Radiation Safety Office

November 21, 2006

re: Control No. 139266

In reply to your letter dated September 22, 2006, the following response is provided. The numbering corresponds to your letter and your request for information is paraphrased for clarity.

3 3rd Floor MCP Hospital

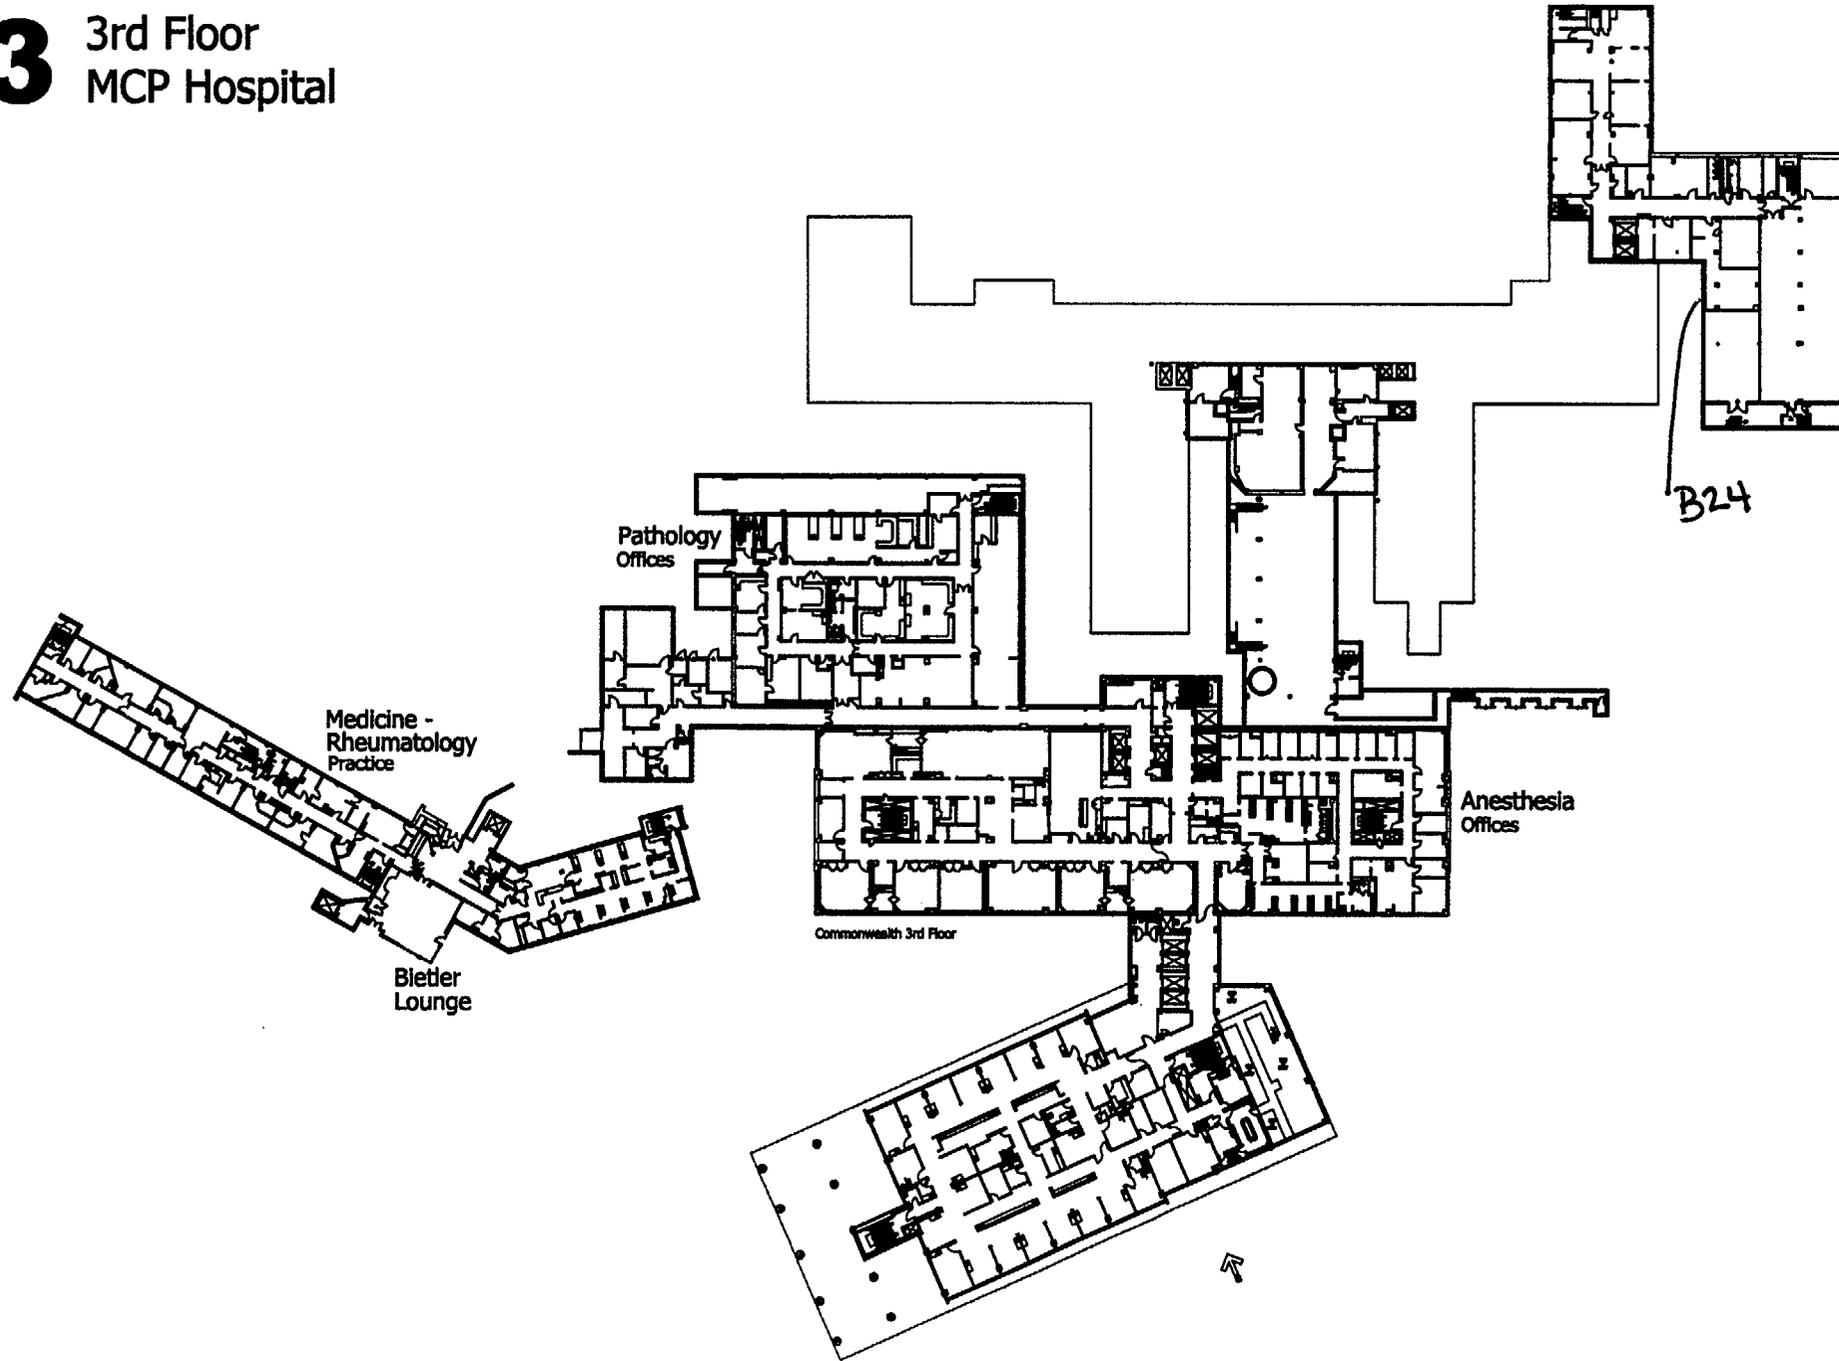
2. In an application dated December 15, 1976 and in an application dated June 19, 1973, certain rooms (listed below) were identified as proposed areas of radioactive use. Surveys were not performed for these areas in your Final Status Survey Report. Please submit surveys for these areas.

Room	Description of Location	Survey Conducted
RIA Room B24/L	In the current floor numbering schema the 3 rd floor was previously referred to as the basement floor. Rooms starting with the letter 'B' are, therefore on the 3 rd floor on the attached facility diagrams. The entire 3 rd floor was reprogrammed to maintenance and facilities management over 15 years ago. The room most likely to have been B24 (evidence includes the presence of a no longer functioning walk-in cooler) is indicated as such on the enclosed facility layout.	The room was visually inspected 4/22/04. Radiation detection instruments were not used as the area was clearly a maintenance area (a large inventory of fan belts are stored in here). It was visually inspected again and surveyed with a thin-window GM survey meter. NRC inspectors also surveyed the room with microrem meters. No evidence of radioactivity was present. Surveyor: Kendall Berry Date: November 14, 2006
